COMMISSION REGULATION (EU) 2016/631

establishing a network code on requirements for grid connection of generators

Figure XX.a

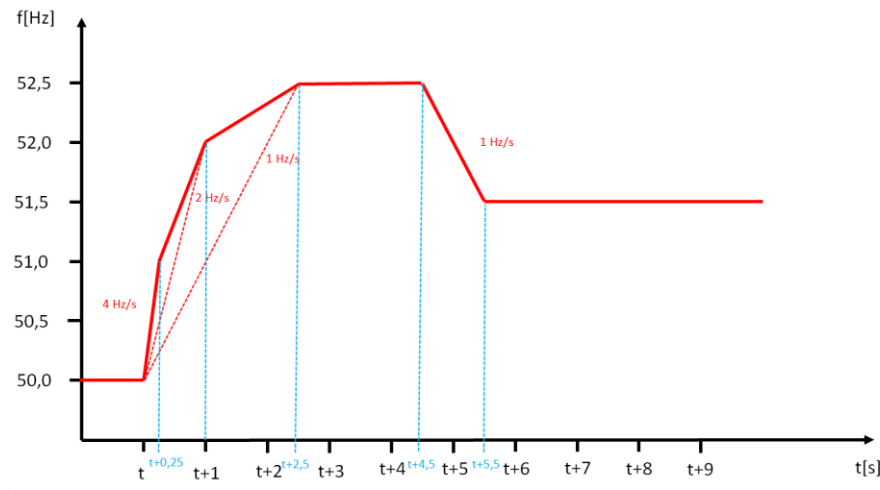
(ii) Without prejudice to Article 13(a) point (i), a power-generating module shall be capable of staying connected to the network and operate at the sequence of rates-of-change-of-frequencies which are defined considering the overfrequency against time profiles given in Figure XX.a and the underfrequency against time profiles given in Figure XX.b;"

Figure 1

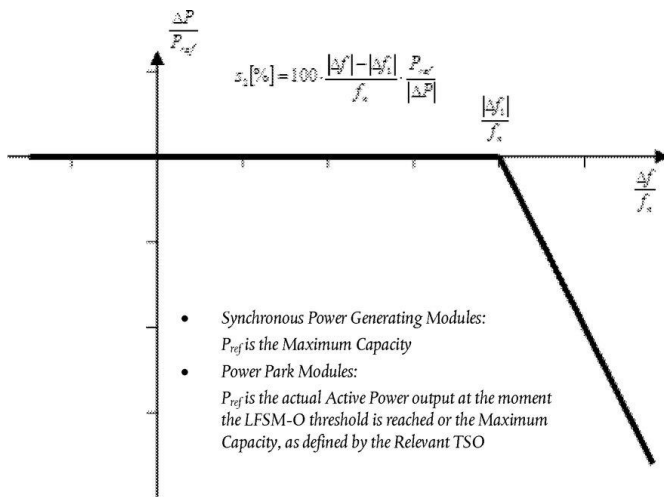
(h) An electricity storage module, regardless whether it is consuming or injecting active power during an overfrequency event, shall increase the level of active power consumed according to the LFSM-O characteristic, to the extent that is technically feasible. The electricity storage module shall consume power up to filling the maximum energy that it is able to store, then it may cease consumption.

In the case of electricity storage modules, P_{ref} could be the actual active power at the moment the LFSM-O threshold is reached or the maximum capacity or maximum consumption capacity, as agreed with the relevant system operator.

Figure YY

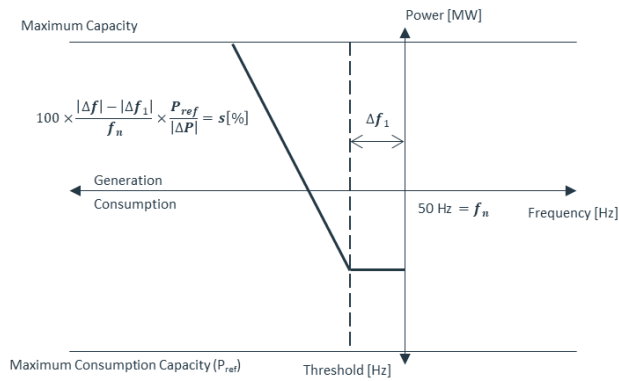
to the maximum capacity according to the indicative Figure YY. The relevant TSO has the right to specify a frequency threshold and a droop setting.

(b) The droop shall be adjustable between 0,2% to 5%. The default droop s shall be 1%.

(c) The frequency threshold shall be adjustable between 49,8 Hz and 49,5 Hz inclusive. The default frequency threshold shall be 50 Hz reduced by Δf_1 where Δf_1 is defined in Table X of Article 15.2.d.

Figure 4

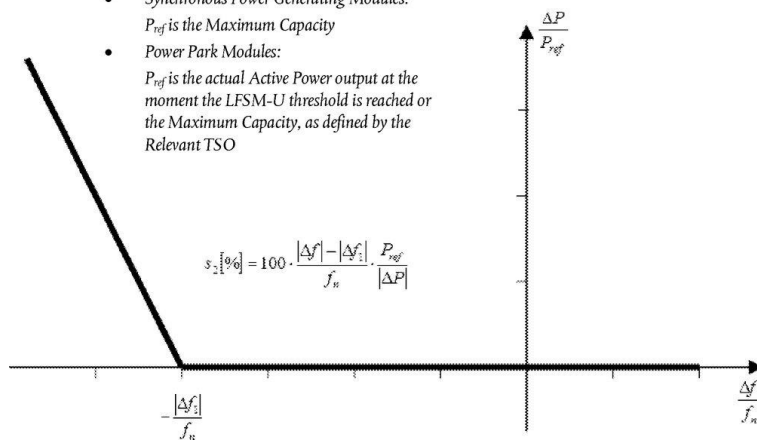
- Synchronous Power Generating Modules:
 P_{ref} is the Maximum Capacity
- Power Park Modules:
 P_{ref} is the actual Active Power output at the moment the LFSM-U threshold is reached or the Maximum Capacity, as defined by the Relevant TSO

P_{ref} is the reference active power to which ΔP is related and may be specified differently for synchronous power-generating modules and power park modules. ΔP is the change in active power output from the power-generating module. f_n is the nominal frequency (50 Hz) in the network and Δf is the frequency deviation in the network. At underfrequencies where Δf is below Δf_i the power-generating module has to provide a positive active power output change according to the droop S_2 . In the case of electricity storage modules, P_{ref} could be the maximum capacity or the maximum consumption capacity at the moment the LFSM-U threshold is reached or the maximum capacity or maximum consumption capacity as agreed with the relevant system operator.

Figure 5

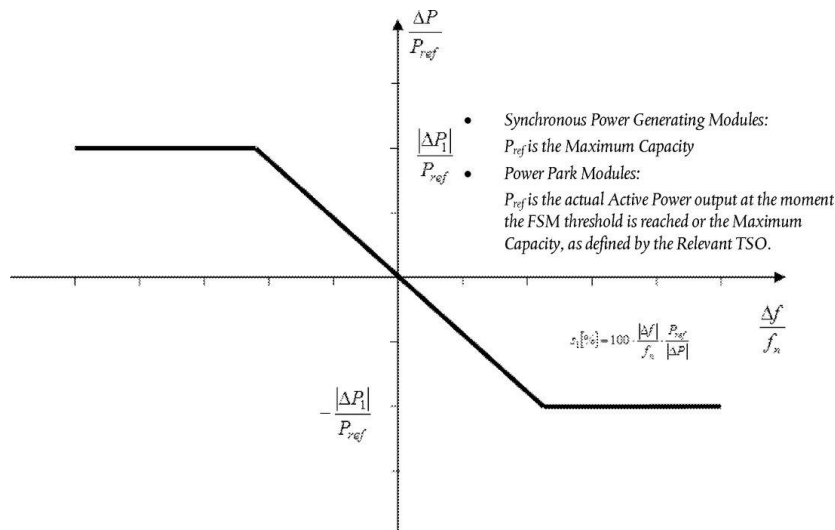
| Parameters | Ranges |
|---|--|
| Active power range related to maximum capacity $\frac{ \Delta P_1 }{P_{\max}}$ | 1,5-10 %, <u>except for electricity storage module.</u> <u>1,5-100% for electricity storage module.</u> |

Hz) in the network and Δf is the frequency deviation in the network. In case of electricity storage module, P_{ref} could be the maximum capacity or the maximum consumption capacity at the moment the FSM threshold is reached or the maximum capacity or maximum consumption capacity as agreed with the relevant system operator.
